Richmond Metropolitan Transportation Authority (RMTA)

All Electronic Tolling ITS & Civil Elements

ADDENDUM-02

ITB Revisions & Final Plans

NB TECH SHELTER PAD SITE PLAN DETAILS

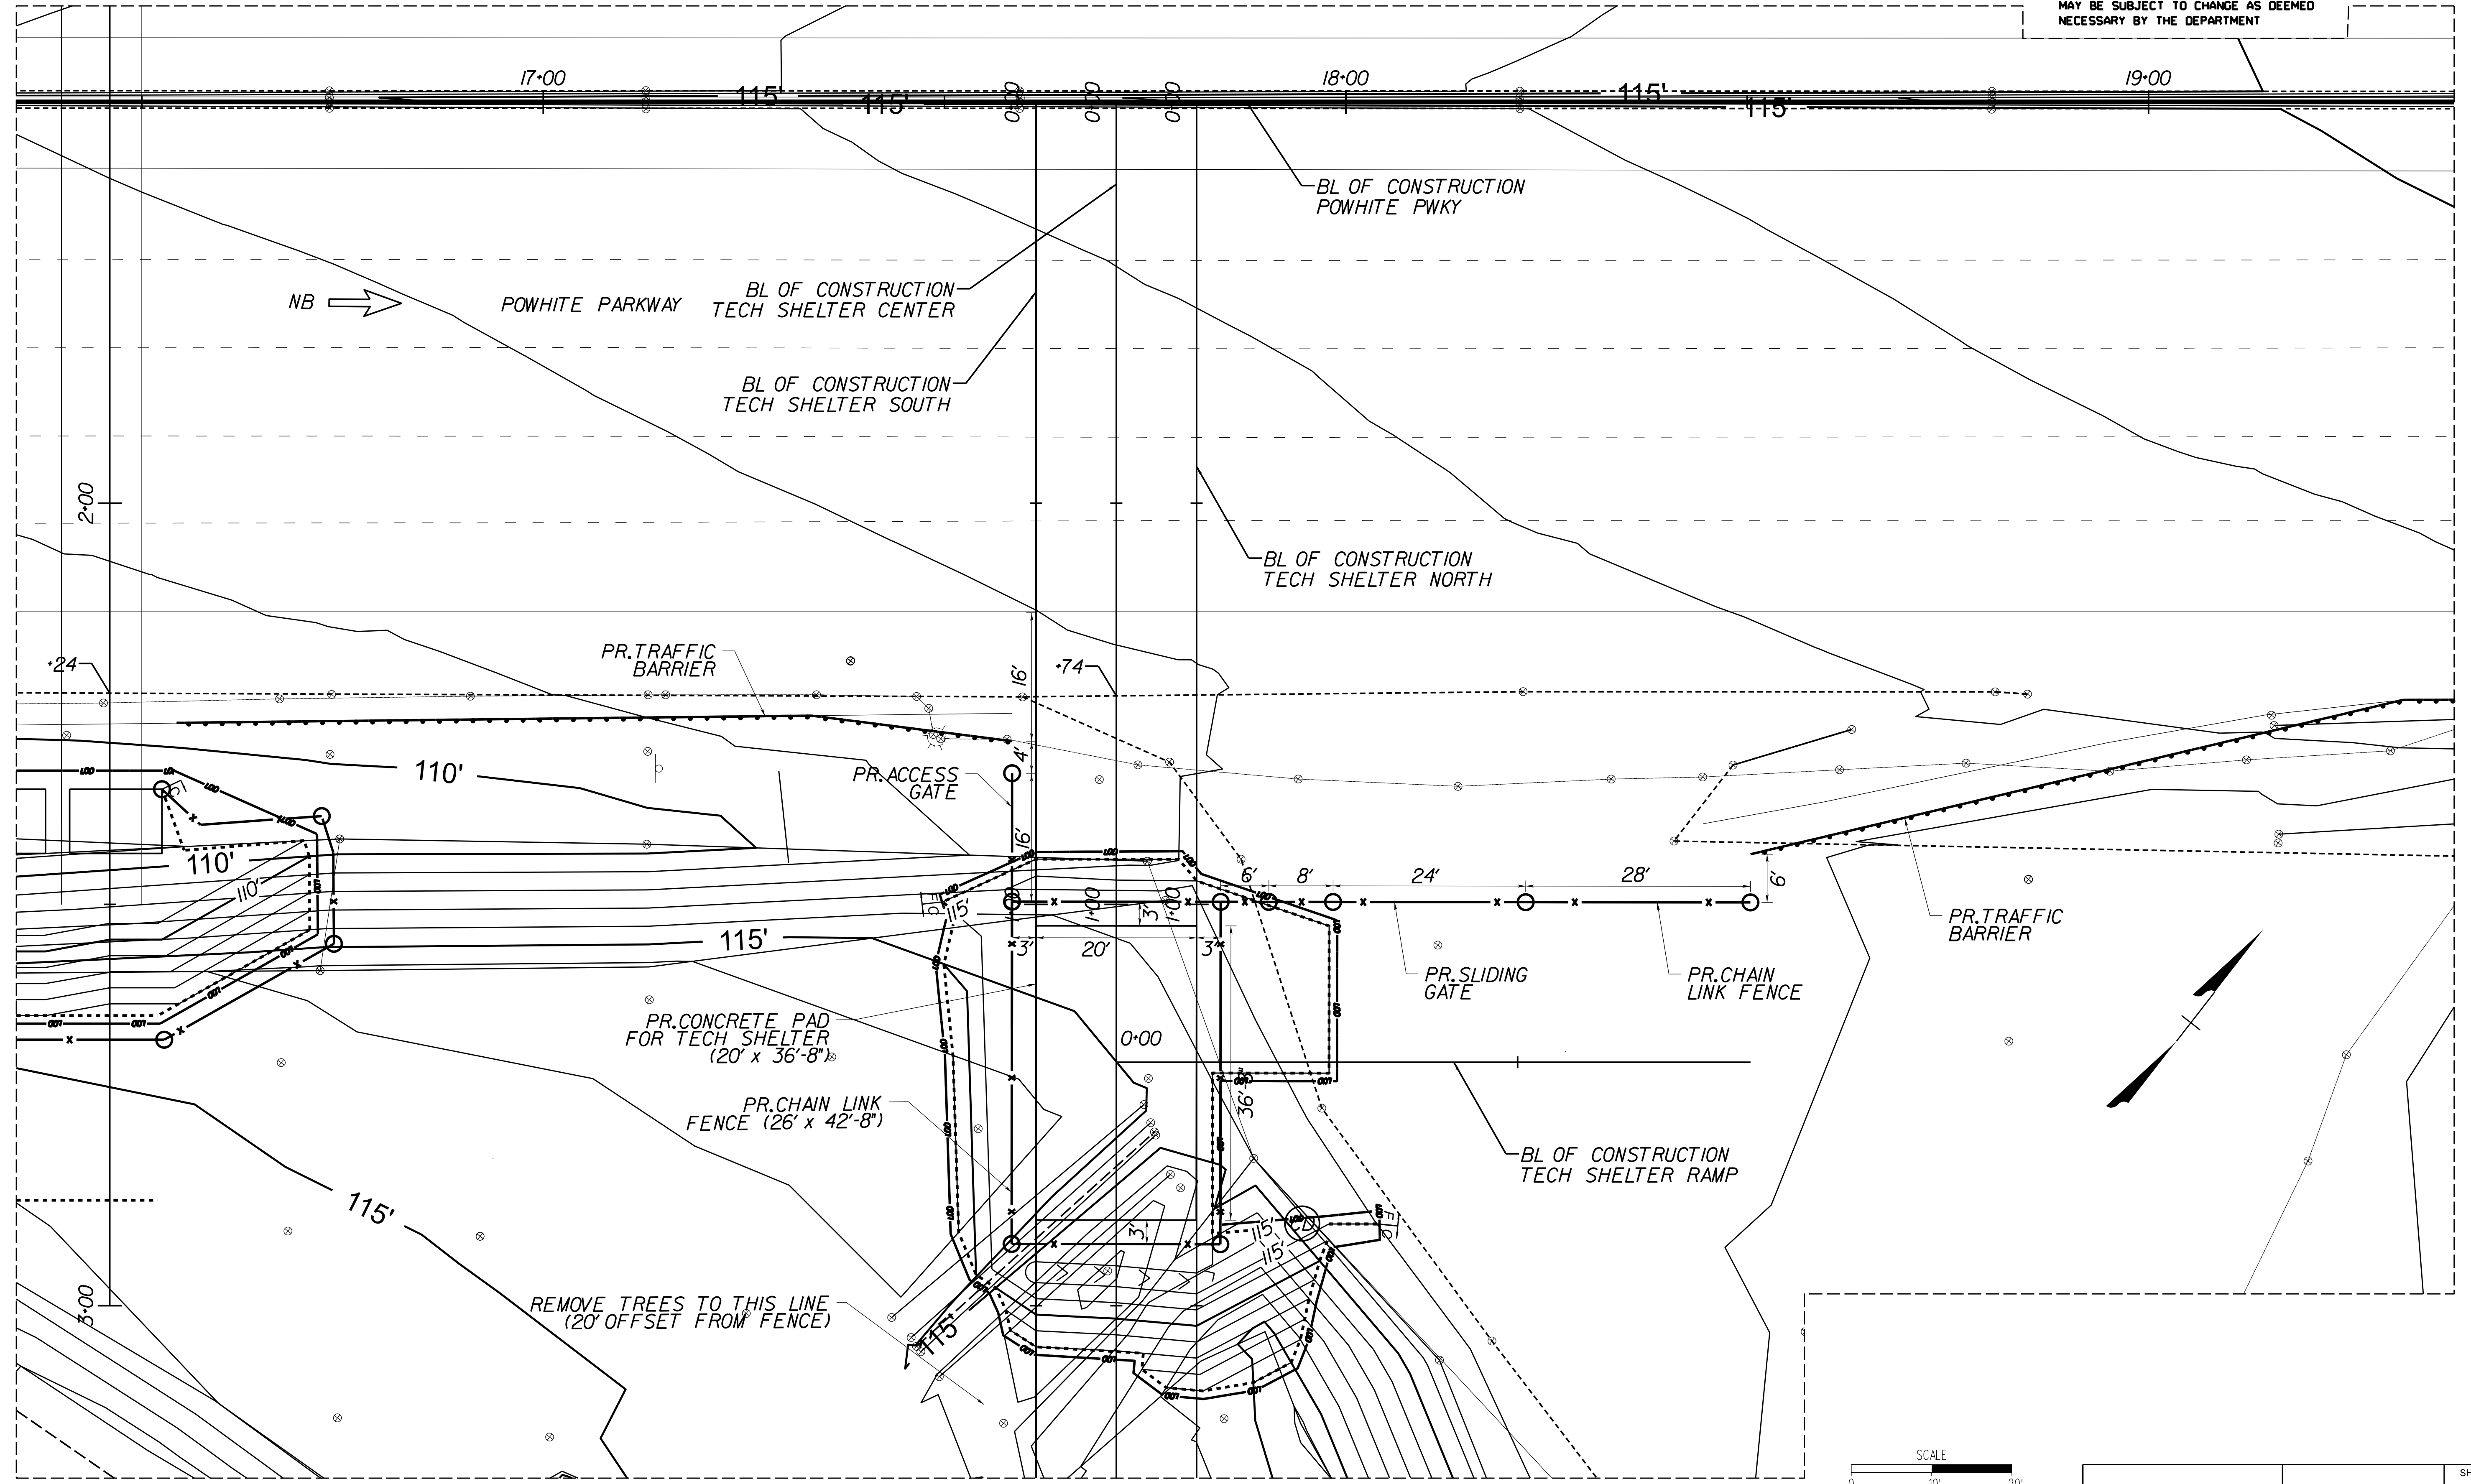
- I. RMTA Supplemental Specifications Index (i, ii) – bookmark errors removed
- J. Special Provision Environmental and Earthwork (SP-F-2) – “Inlet Protection Ty. A” changed to “Inlet Protection Ty. B”; added “Check Dam (Rock) TY. II

▽ (CD) DENOTES ROCK CHECK DAM, TYPE II, VDOT ST'D EC-4.
